To: City of Manor
From: GBA
Date: 4/2/2025
Subject: Change Order No.1 for the Manor Commercial Park Wastewater Collection System and Carriage Hills Lift Station #5 Improvements Phase 1.

Date:	March 24, 2025
Project:	Manor Commercial
Change Proposal No.	1
Description:	Extend Pipe 41.68 Feet to new tie-in point at Carriage Hills. Pipe price is already established in the bid and will be accounted for in an overrun. The following Change Proposal is for traffic control, asphalt patching, curb, and gutter, flowable fill, misc. equipment and materials.
Per Revision Dated: 1/20/2025	In the event of a ditch failure within the asphalt and curb and gutter section that is unavoidable and has been experience thus far on the job, we would expect to be compensated for the additional quantities and time.

12IN PVC WASTEWATER LINE A (4 OF 4)

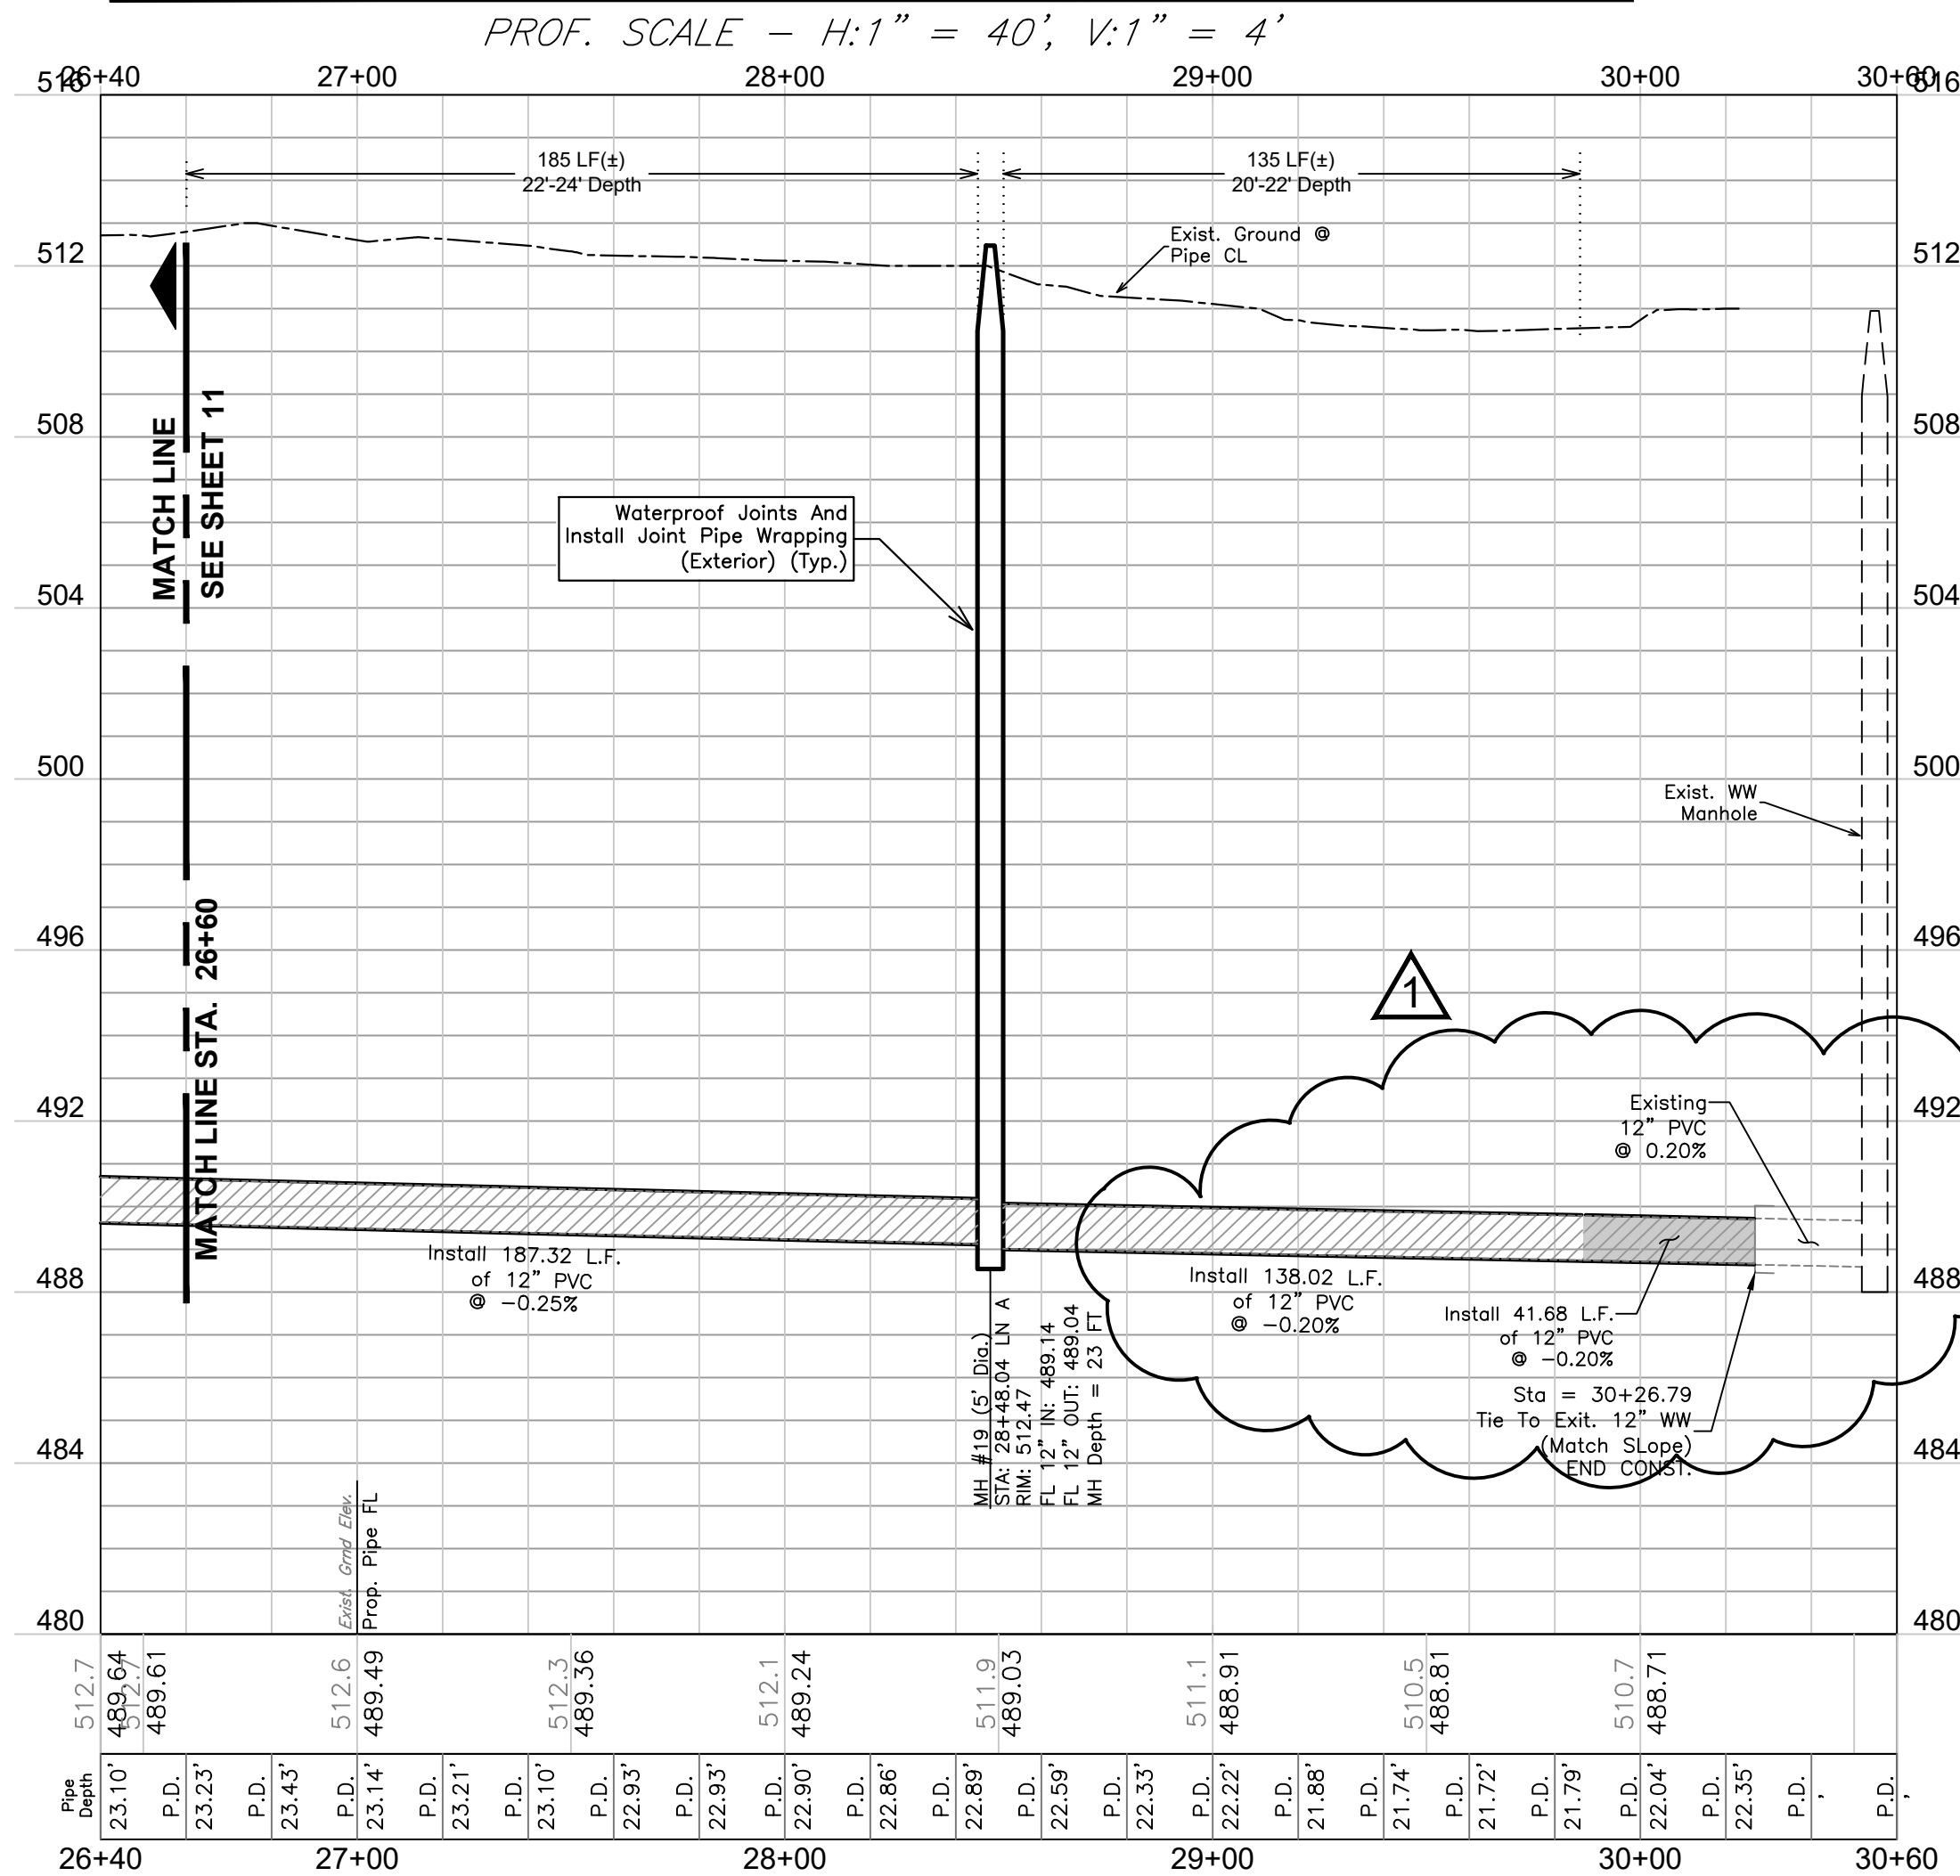
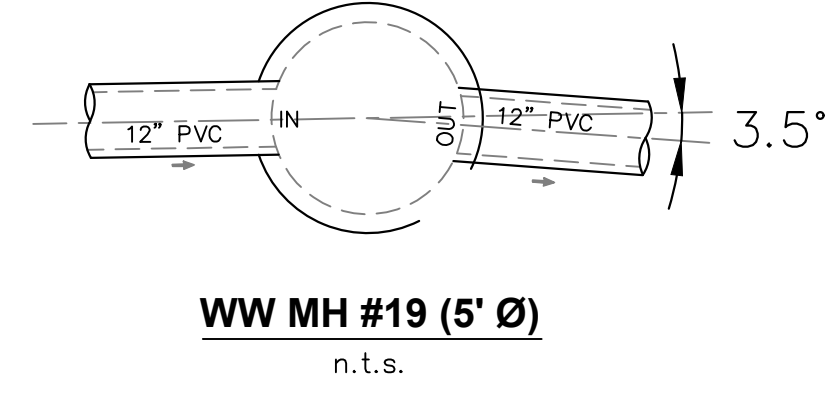
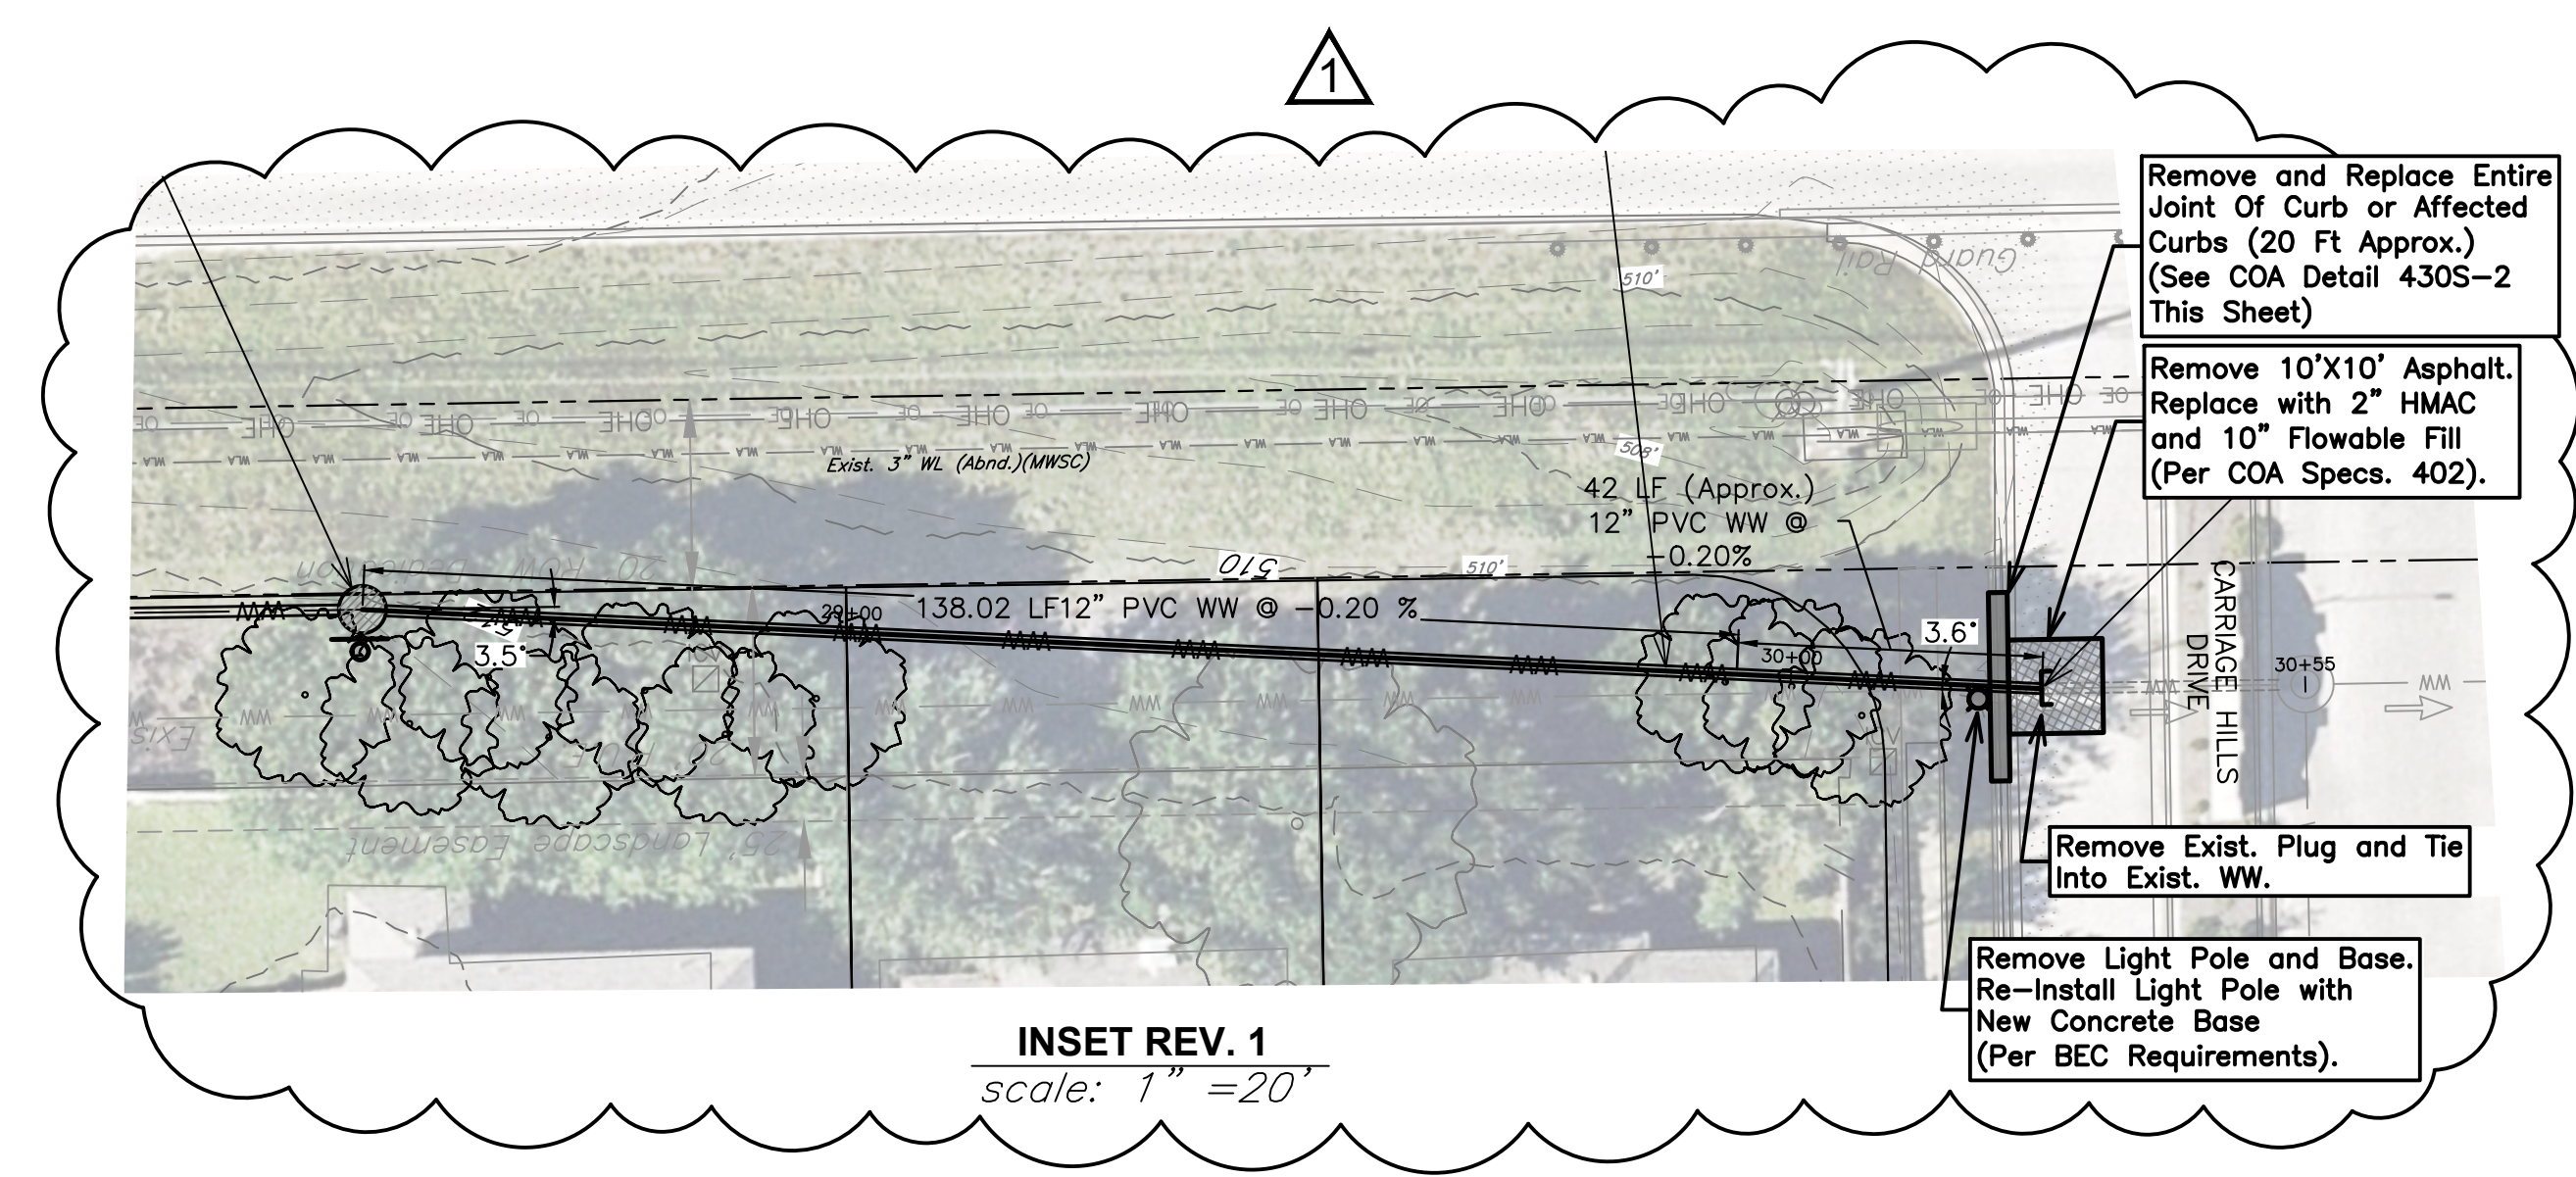
The stub out for the tie-in point of the wastewater line as called out in the as-builts was not installed per the plans in 2006. This stub out is located approximately 42' further west, requiring additional linear feet of pipe.

The associated work for this installation will require additional linear feet of pipe, a traffic control plan, curb and street repair. An additional 5 calendar days will be added to the final completion date.

REVISION		
△	Rev. WW From MH #19 To Ex. Cap/Plug	PMG 01/15/25
PROJECT NUMBER 15072.00		
DATE 1/20/2025		
DESIGNED TS		
DRAWN JJD		
REVIEWED FTP/PG		
MUNICIPALITY		
CIP Project		
NA		
SHEET NUMBER		
9
